**UN Global Technical Regulation No. 13
(Hydrogen and Fuel Cell Vehicles)****Proposal for Corrigendum 1 to Amendment 1 to
UN Global Technical Regulation No 13 (Hydrogen and Fuel
Cell Vehicles) *****Submitted by the expert of the Informal Working Group on UN Global
Technical Regulation No. 13, Phase 2**

The text reproduced below was prepared by the chair of Informal Working Group (IWG) on hydrogen and fuel cell vehicles (HFCV), UN Global Technical Regulation No. 13, Phase 2 (GTR13-PH2) and proposes to correct editorial errors to the text of Amendment 1 to UN Global Technical Regulation No 13. It is based on GRSP-73-26-Rev.1 distributed at the seventy-third session of the Working Party on Passive Safety (GRSP). The modifications to the existing text of the UN Global Technical Regulation No. 13 (ECE/TRANS/180/Add.13 and Amend.1) are marked in bold for new or strikethrough for deleted characters.

"Figure 3

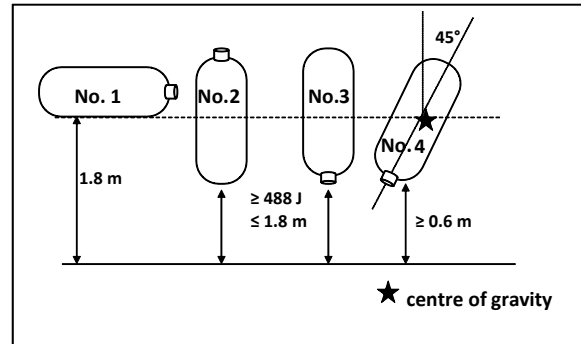
Figure 3 in paragraph 6.2.3.2., amend to read (correct the place of words in the drawing):
